Access Compliance Report Public Rights-of-Way (Curb Ramps)

Main Street: RANCHWOOD_RD **Cross Street:** RAINBOW_DR **Location:** NW

ADA ID: RPRK211006115254 **Ramp Type:** Type 1 - Perpendicular Diagonal Initial Pass/Fail: Fail **Overall Compliance:** No **Severity Score:** 16

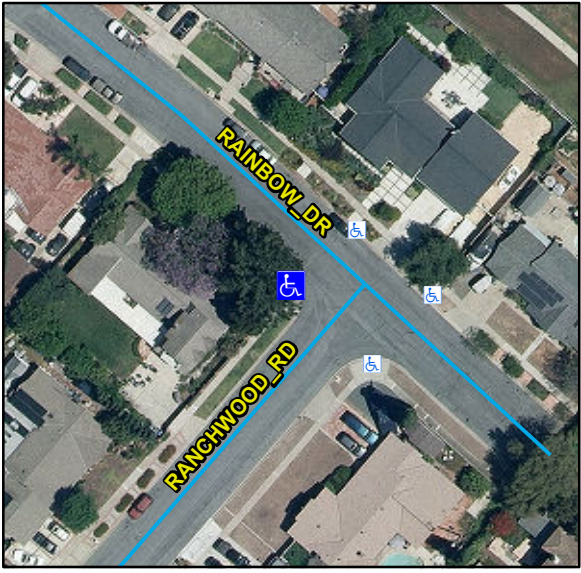
Compliance	Description	Data	Compliance	Description	Data
N/A	Ramp Length (in)	126	N/A	Flare Type LT	
Yes	Ramp Width (in)	48			N/A
No	Ramp Run Slope (%)	9.5	N/A	Flare Slope LT (%)	N/A
No	Ramp Cross Slope (%)	3.7	N/A	Flare Traversable LT	N/A
N/A	Landing Present	N/A	N/A	Flare Type RT	
N/A	Landing Length (in)	N/A			N/A
N/A	Landing Width (in)	N/A	N/A	Flare Slope RT (%)	N/A
N/A	Landing Run Slope (%)	N/A	N/A	Flare Traversable RT	N/A
N/A	Landing Cross Slope (%)	N/A	N/A	DWS Provided	N/A
N/A	Landing Movement Obstructed?	N/A	N/A	DWS Contrast	N/A
	Landing Movement Type	N/A	N/A	DWS Length (in)	N/A
N/A	Landing Shared	N/A	N/A	DWS Full Width	N/A
N/A	Clear Space	Yes	N/A	DWS Offset Left (in)	N/A
N/A	Clear Space To Crosswalk (in)	N/A	N/A	DWS Offset Right (in)	N/A
N/A	Marked Crosswalk 1	No	N/A	Marked Crosswalk 2	No
	Crossing 1 Direction	S		Crossing 2 Direction	E
	Marked Crosswalk 1 Width (in)	N/A		Marked Crosswalk 2 Width (in)	N/A

N/A	Ramp Inside Crosswalk 1	N/A	Yes	Ramp Inside Crosswalk 2	N/A
	Crossing 1 Slope (%)	10.6		Crossing 2 Slope (%)	6.1
	Crossing 1 Cross Slope (%)	0.5		Crossing 2 Cross Slope (%)	1.6
N/A	Gutter Ponding	N/A	N/A	Curb Slope	3.9
Yes	Gutter Lip Height (in)	0		Road Run Slope (%)	1.9
N/A	Gutter Run Slope (%)	N/A		Road Cross Slope (%)	1.4
N/A	Gutter Cross Slope (%)	N/A			
Yes	Overall Surface Condition: Acceptable		No	Perp Joint Present	No
	Cross Gutter Present?	No		Spandrel Present?	No
	Replace Cross Gutter?	N/A		Replace Spandrel?	N/A

Possible Solutions:
Remove & Replace Curb Ramp With Two New Directional Ramps or Equivalent.
